Our Reference: 1621035  
Council Reference: SUB2021/0042  
Contact: Peter Bell / Madison Ruygrok

**FULL RESPONSE TO COUNCIL'S ADDITIONAL INFORMATION REQUIRED LETTER – DEVELOPMENT APPLICATION FOR A 332 LOT SUBDIVISION (327 RESIDENTIAL LOTS, 1 RESIDENTIAL LOTS, 1 COMMERCIAL LOT, 4 DRAINAGE RESERVES AND ASSOCIATED PUBLIC OPEN SPACE AREAS) AT JAMES CREEK ROAD, JAMES CREEK (LOT 104 DP751388) ('SUBJECT SITE')**

Figure 3: Road 1 Section Ch 0.00-Ch 54.00

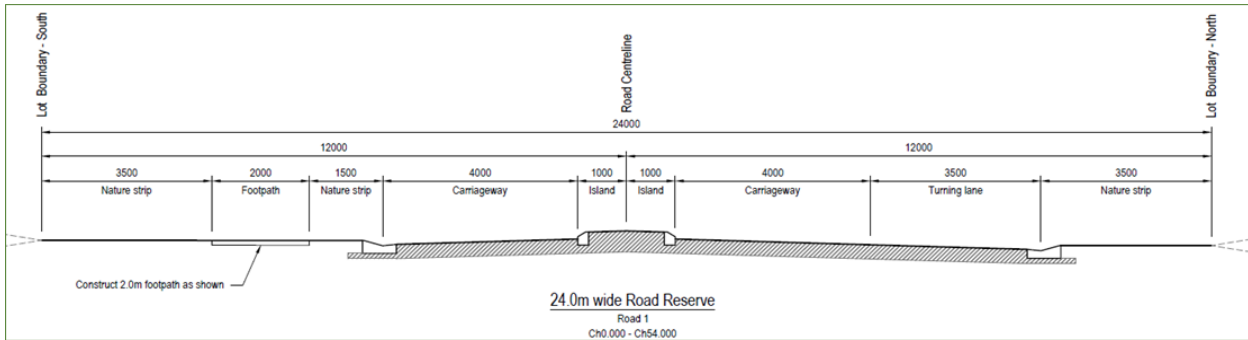
Road 1 (entry road) – Ch 0.00-Ch 54.00 carriageway should be 13m based on traffic volumes for the subdivision.

The carriageway here is already 13.5m including the central median. Note that there are 328 residents lots proposed (excluding the medium density lot). At the standard rate of 9 trips per lot per day, this equates to 2,952 total trips per day. Using rate of 7.4 daily trips per dwelling as suggested by RMS for regional areas (as per Technical Direction TDT 2013/04a, Guide to Traffic Generating Developments: Updated Traffic Surveys), this gives a total of under 2,500 trips per day. In either case, based on the traffic volume Table D1.5 of Northern Rivers Local Government (NRLG) design spec D1 classifies Road 1 (Ch. 0 To Ch. 54) as a Collector Street, with a min. carriageway width of 11m. Subtracting the centre island and only including invert-to-invert travel lanes, the carriageway width for Road 1 (Ch. 0 To Ch. 54) is greater than this at 11.5m (refer to Figure 3 below).

Figure 4: Lots highlighted use Road 1 beyond Ch. 54

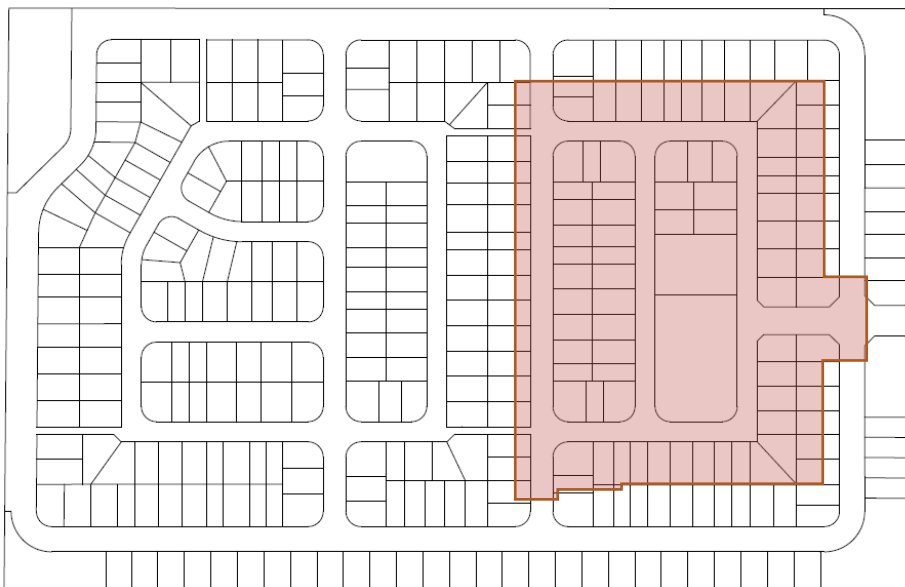
Road 1 – Justification based on traffic volumes is to be provided for carriageway width of 8.0m between Ch 54.00 to end

Only those lots highlighted below will need to use Road 1 beyond Ch. 54 (i.e. west of the intersection with Road 2) (refer to Figure 4 below). This is 85 lots plus the medium density lot. Even with additional traffic generated by the open space (which is unlikely to add much vehicular traffic to Road 1), assuming the rate of 9 trips per dwelling per day, the maximum traffic using this section of Road 1 is under 1,000 trips per day. Thus, Table D1.5 of NRLG design spec D1 classifies Road 1 (Ch. 54 to End) as a Local Street, with a min. carriageway width of 7-9m. The proposed design is 8m from invert-to-invert.

Figure 5: Lots highlighted expected to use Road 2 between Ch. 830 and Ch. 1840

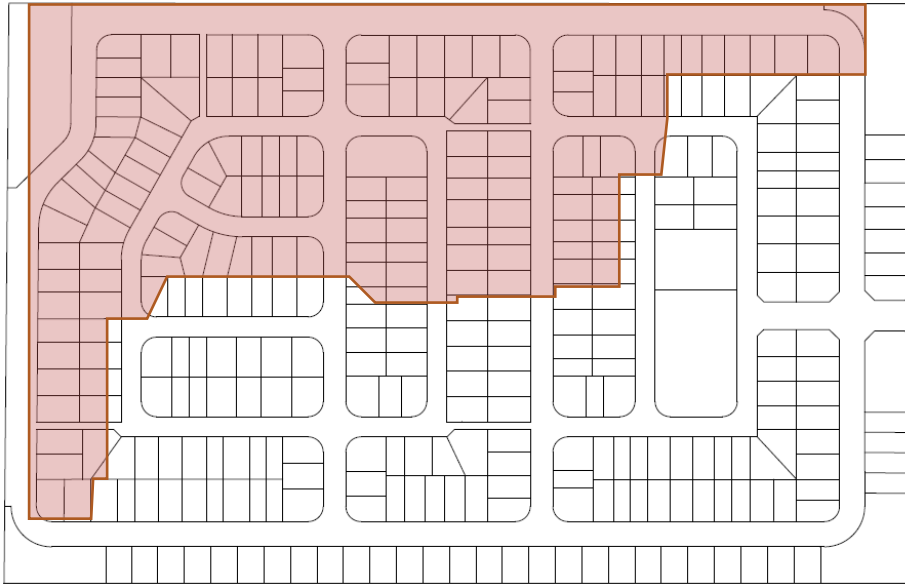
Road 2 (loop road) – Justification based on traffic volumes is to be provided for the reduced road carriageway width of 8.0m for Road 2 between Ch 830.00 and Ch 1840.

Only those lots highlighted below in Figure 5 are expected to use Road 2 between Ch. 830 and Ch. 1840 (i.e. along the western and northern perimeters). This is 125 lots. Assuming the rate of 9 trips per dwelling per day, the maximum traffic using this section of Road 2 is under 1,125 trips per day. Thus, Table D1.5 of NRLG design spec D1 classifies Road 2 (Ch. 830 To Ch. 1840) as a Local Street, with a min. carriageway width of 7-9m. The proposed design is 8m from invert-to-invert.

Noting that Road 2 forms the major bus route, in accordance with Note 10 of Table D1.5 of the NRLG design spec D1, Road 2 includes a min. 7.0m travel way with indented parking and bus bays. All inside curves at bends and intersections will have radii in accordance with D1.17.11. Proposed bus stops have been located such that at least 95% of all dwellings will be within a 400m walking distance, in accordance with D1.21.1.

Figure 6: Section of Auston Lane planting buffer

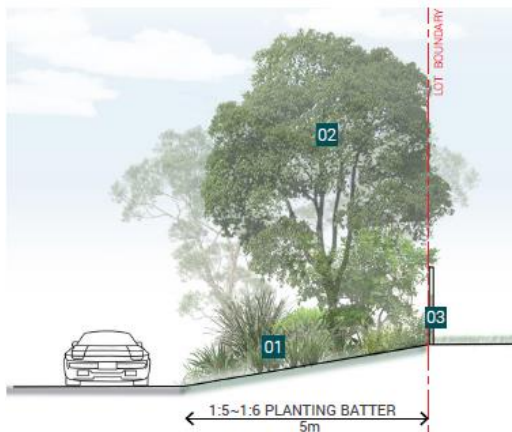
The proposed planted buffer to Austons Lane shall be designed so that it is responsive to existing vegetation/trees and site topography. This may include varying the widths of the buffer in response to vegetation, topography and the proposed finished earthworks. Details to be submitted for consideration, including a tree survey that demonstrates which trees are proposed to be retained or removed.

The proposed planting buffer to Austons Lane has been designed so that it is responsive to existing vegetation/trees and site topography as requested by Council. Refer to details within Enclosure 6 – Statement of Landscape Intent.

The proposed planting buffer is situated on a 1:5 to 1:6 batter for the full extent of the southern property boundary (refer to Section in Figure 6 below). The planting consists of low maintenance native planting species comprising of trees, shrubs and ground covers proposed at a density of 1 Tree per 5m<sup>2</sup> / 1 Shrub per 5m<sup>2</sup> / 3 Groundcovers per 5m<sup>2</sup>.

Every effort has been made by the Applicant to retain to existing trees along the property boundary to assist in maintaining some of the existing landscape character and interface for the rural residential properties to the south of the site. The trees shown for retention have been informed by the tree survey appended to the SLI. At the top of the batter, behind the proposed landscape buffer is an 1800mm high Black PVC Coated Chainmesh fencing that assists in delineating the new proposed residential property boundary (refer to Figure 7 below).
